# APPROVED MINUTES

## January 18, 2024, Standards Committee Meeting

RE: Minutes from the January 18, 2024, Standards Committee Meeting

E 801-TPAR-02 PEDESTRIAN DETOUR CORNER CLOSURE (proposed new)

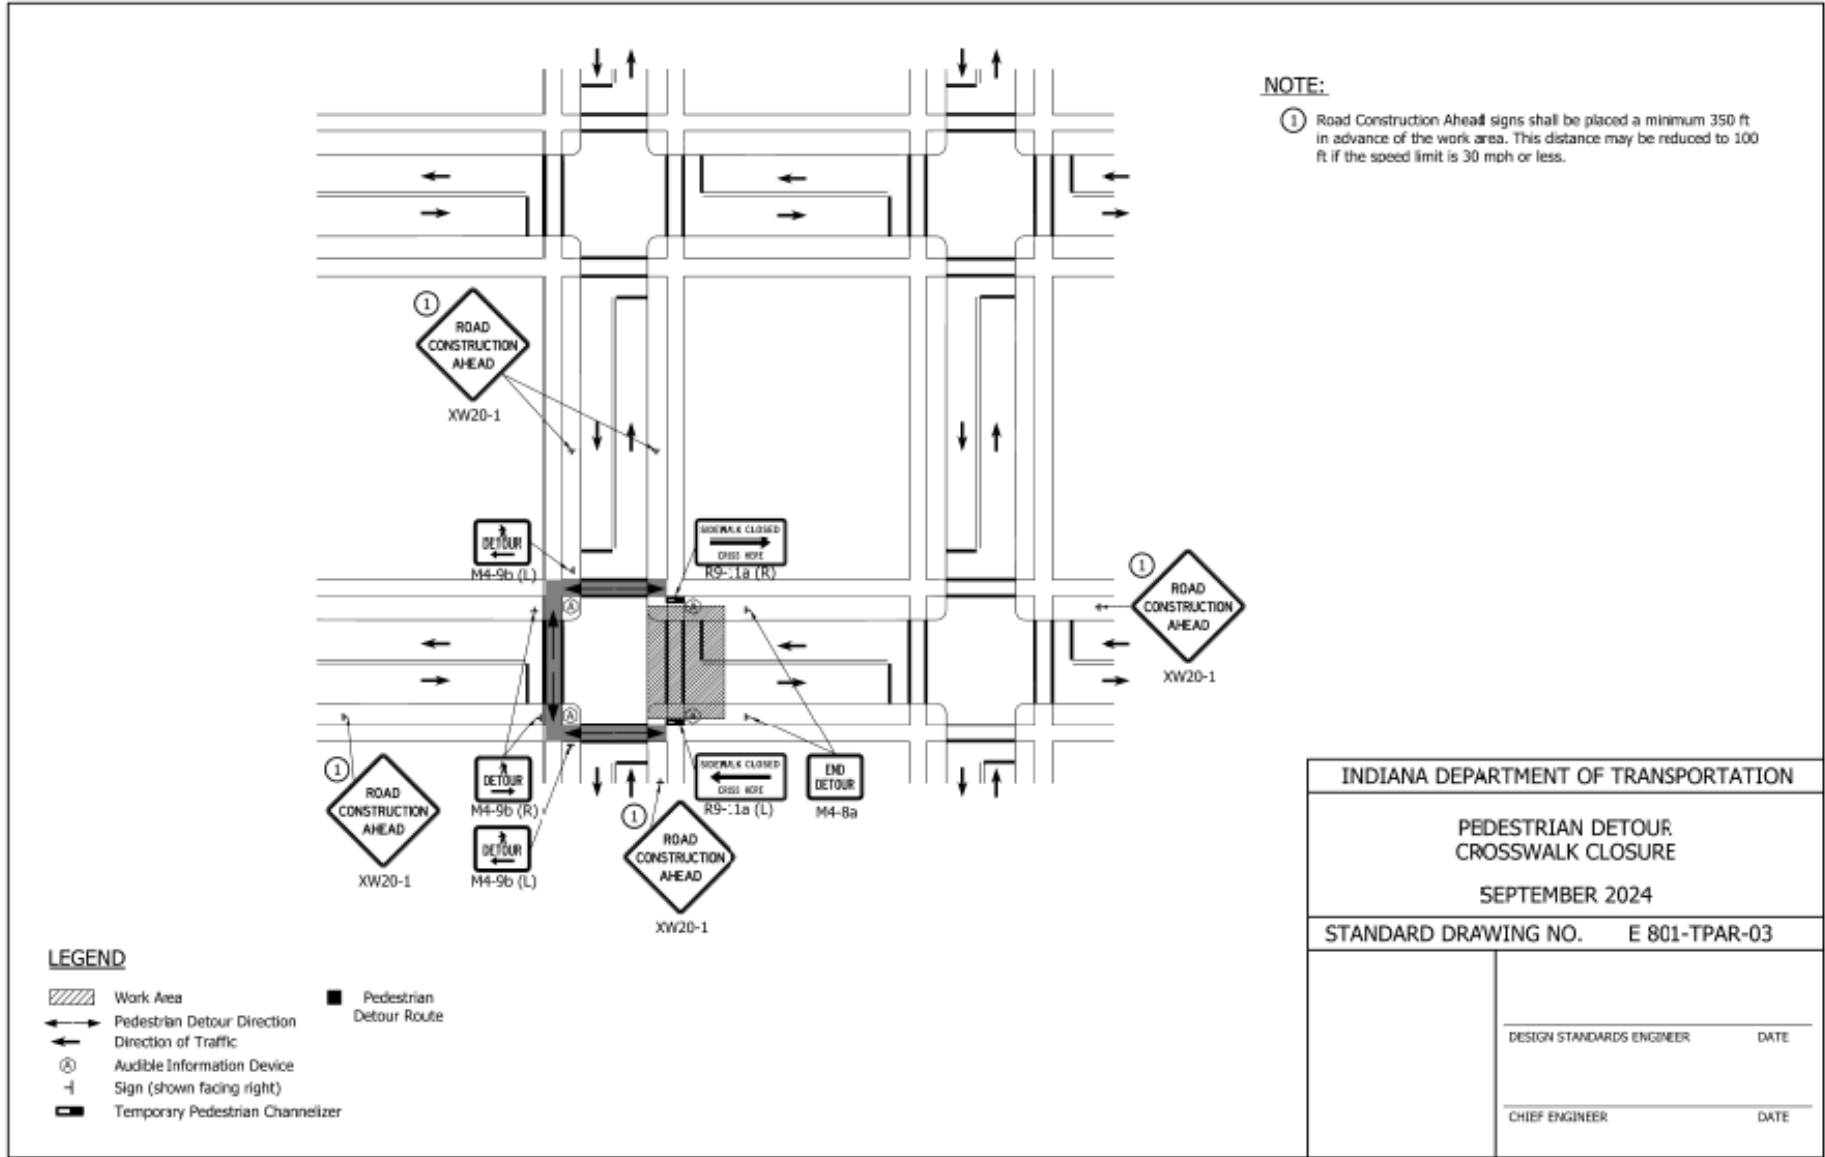
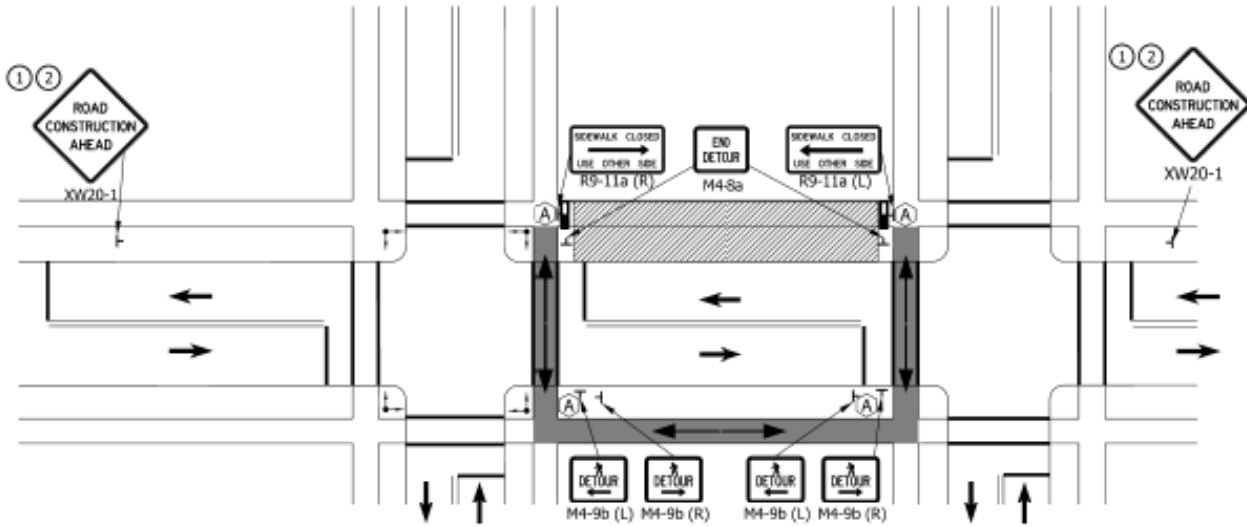
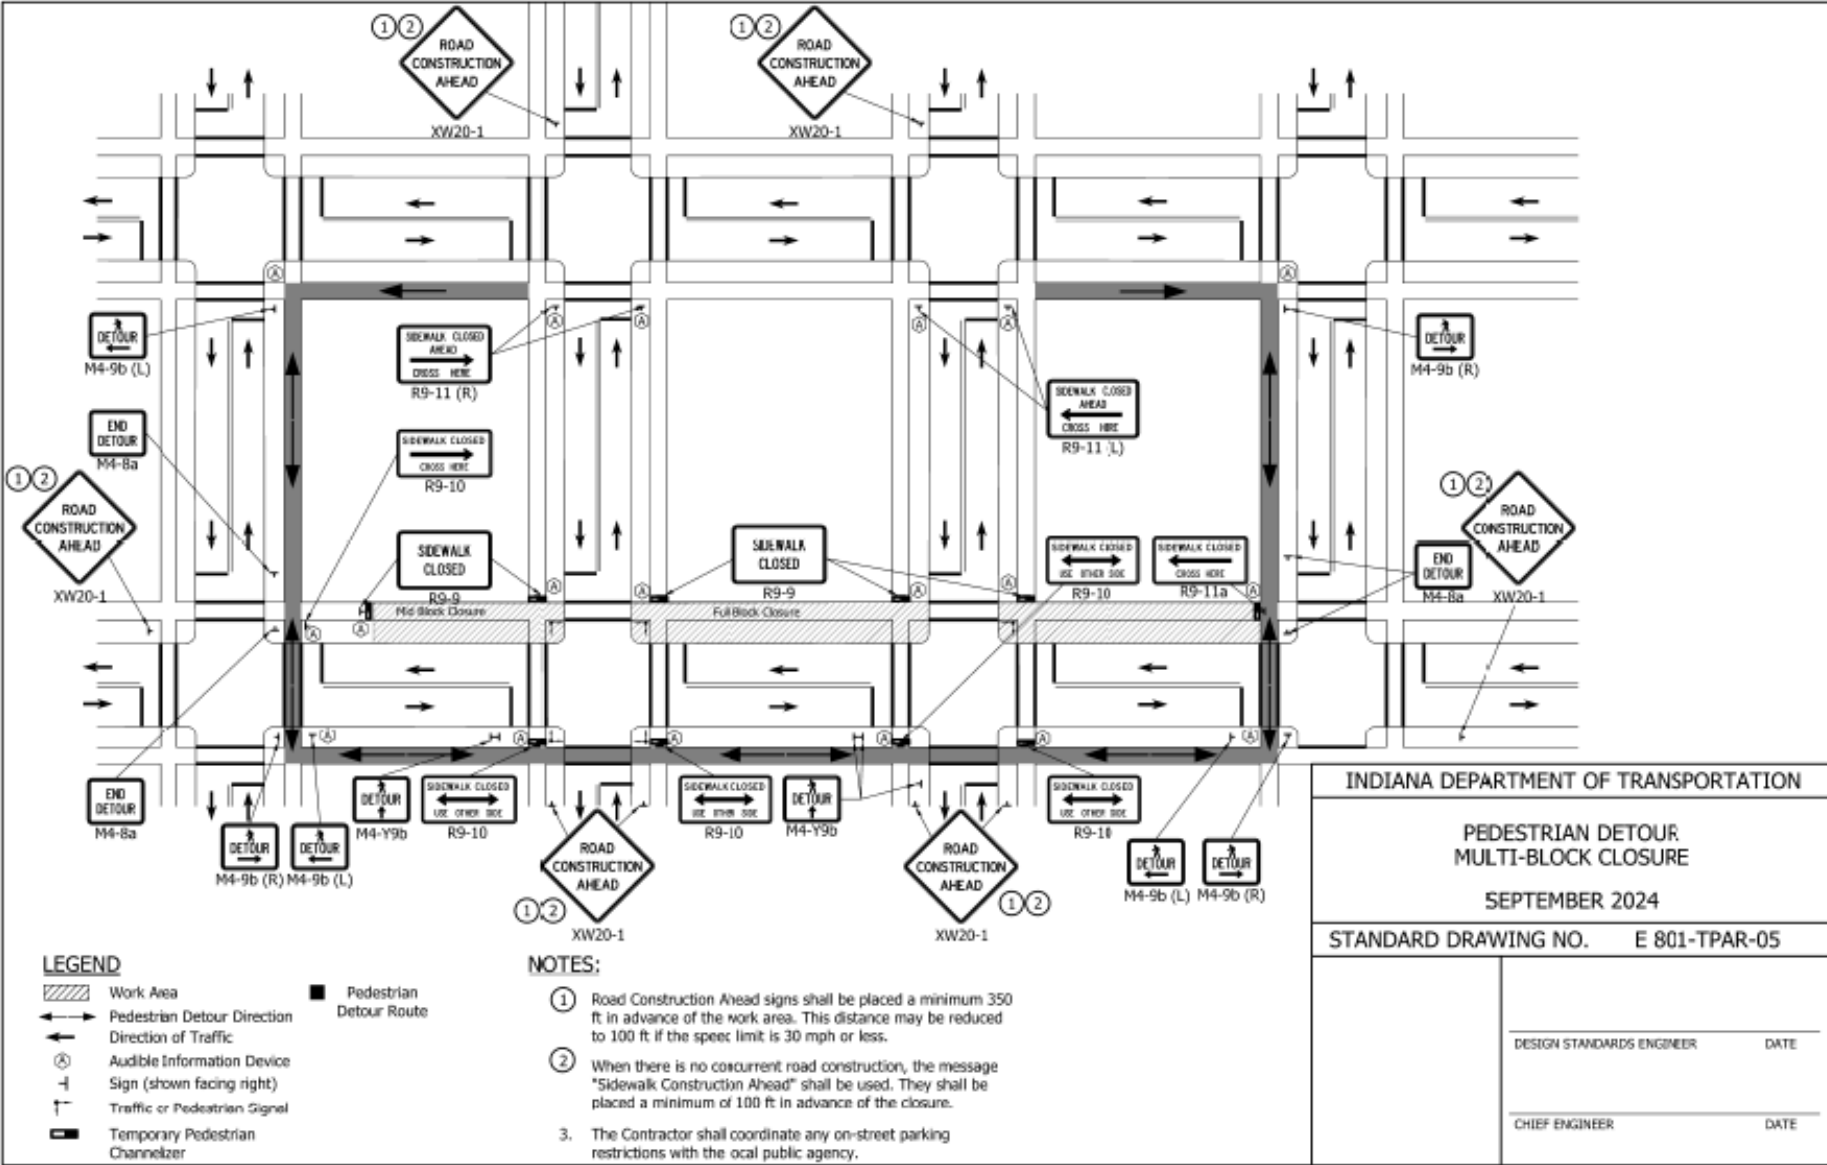
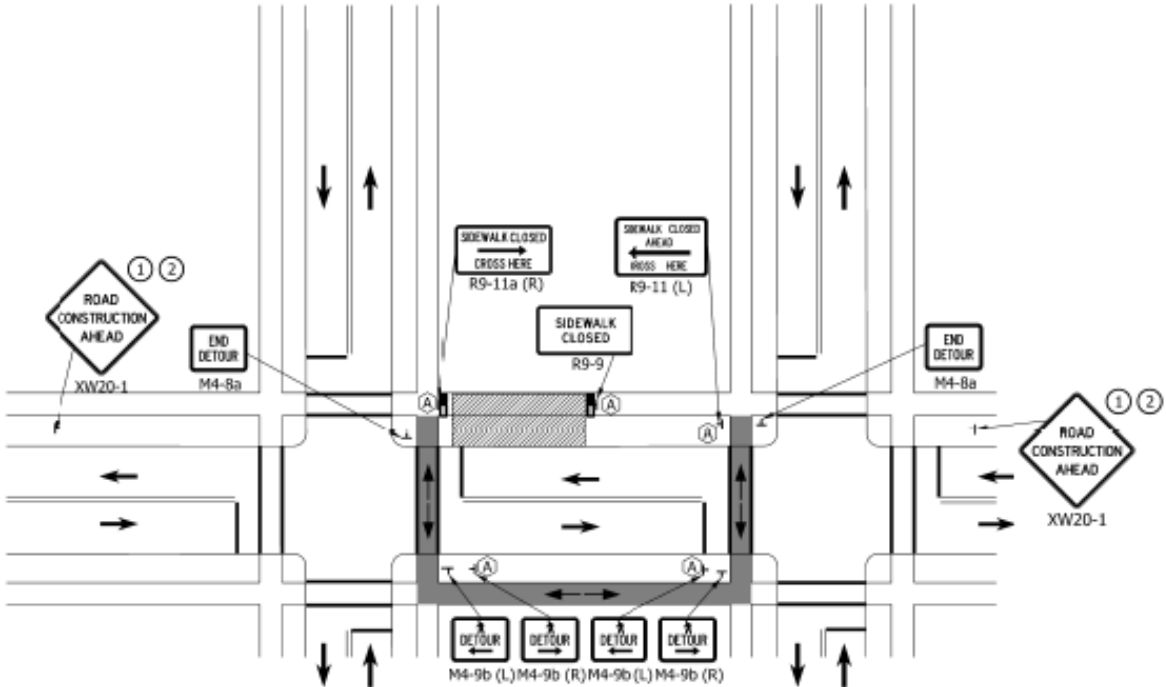
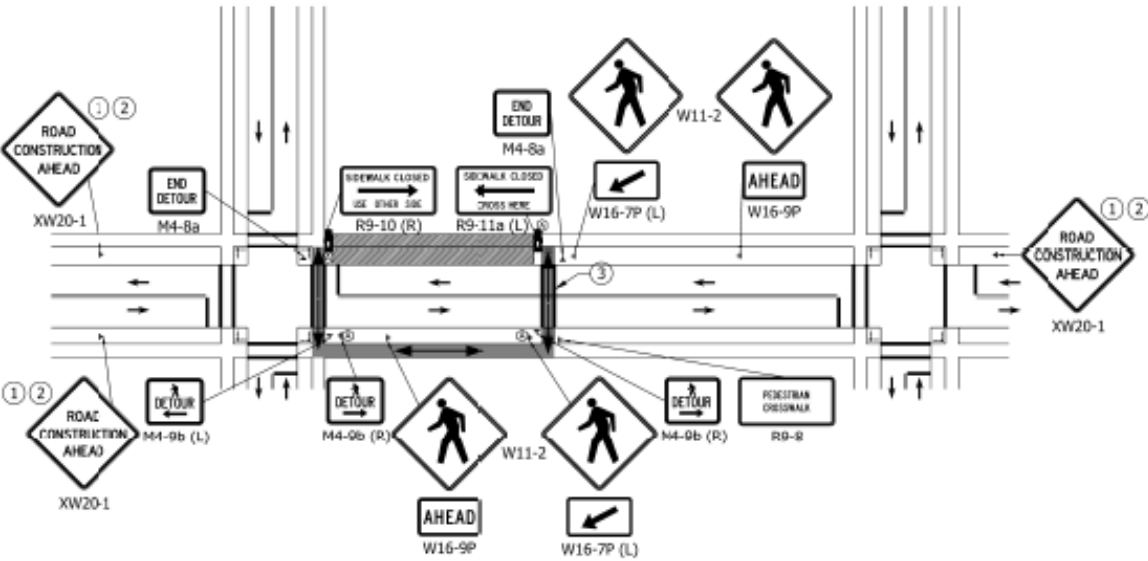
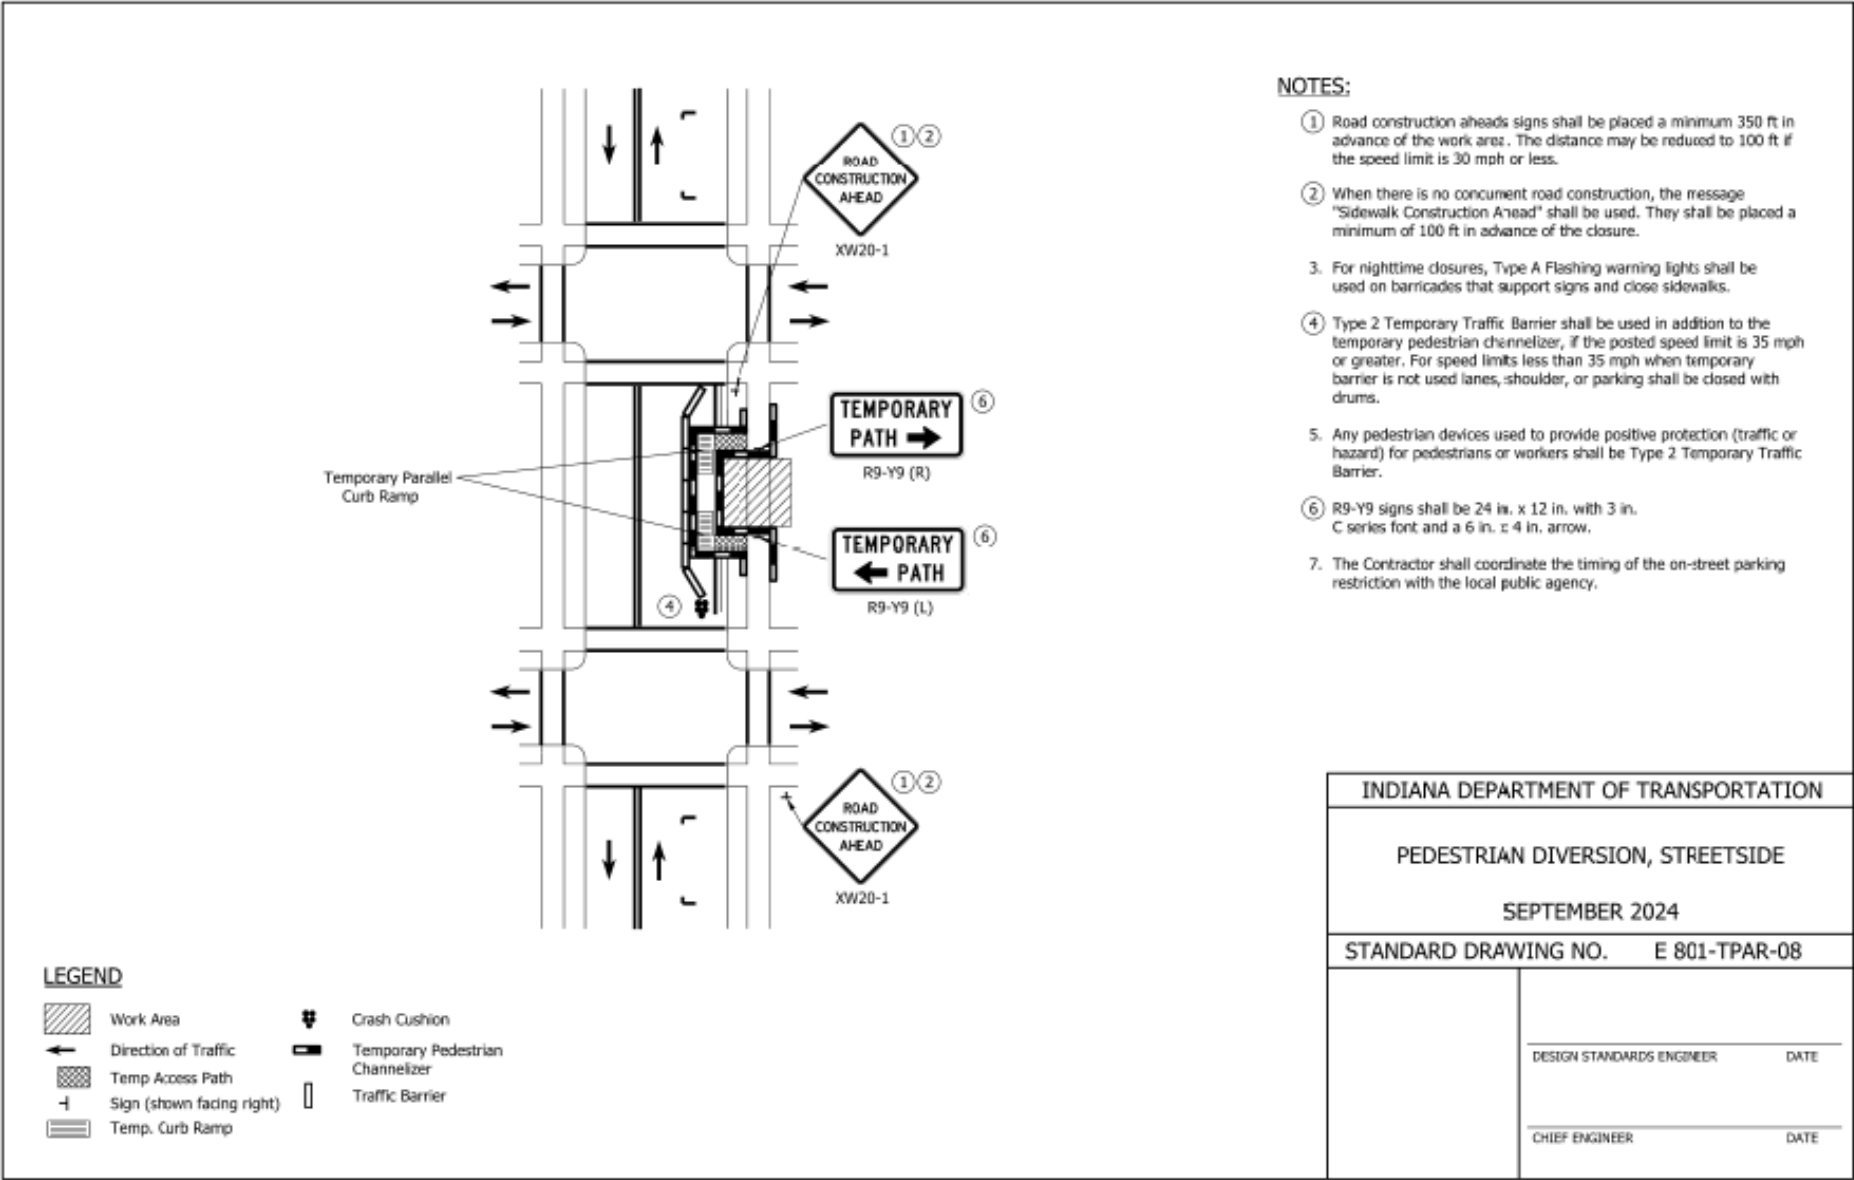
Mr. Koch stated, concerning the 801-TPAR drawings-02, -04, -05, -06, -07, -08, -10: everyone has RCA's. In order to minimize costs, burdens, and liability if the note is overlooked, and the associated costs to change out signage as the work progresses and to maintain a stock of the signs; please consider striking note #2. Also, for drawings 801-TPAR-03, -05, -07, understand we are attempting to capture both approaching sidewalks yet we are adding a considerable amount of sign clutter. Are two RCA's needed as a single is utilized elsewhere? And for 801-TPAR-10, the corner diversion requires 'sidewalk construction ahead' yet includes note #2. Similar to elsewhere, should RCA's be required 1<sup>st</sup>, ideally only RCA's for simplification. Mr. Boruff responded that we could make it an option, which would eliminate the liability and added costs concerns. The Contractor can use RCA's if they have them in stock or would otherwise prefer the alternate, more precise message. Mr. Koch said that sounds reasonable. The drawings have been revised as shown, following discussions by Mr. Duncan from FHWA, Mr. Koch, Ms. Smutzer, Mr. Davis, and Mr. Boruff.
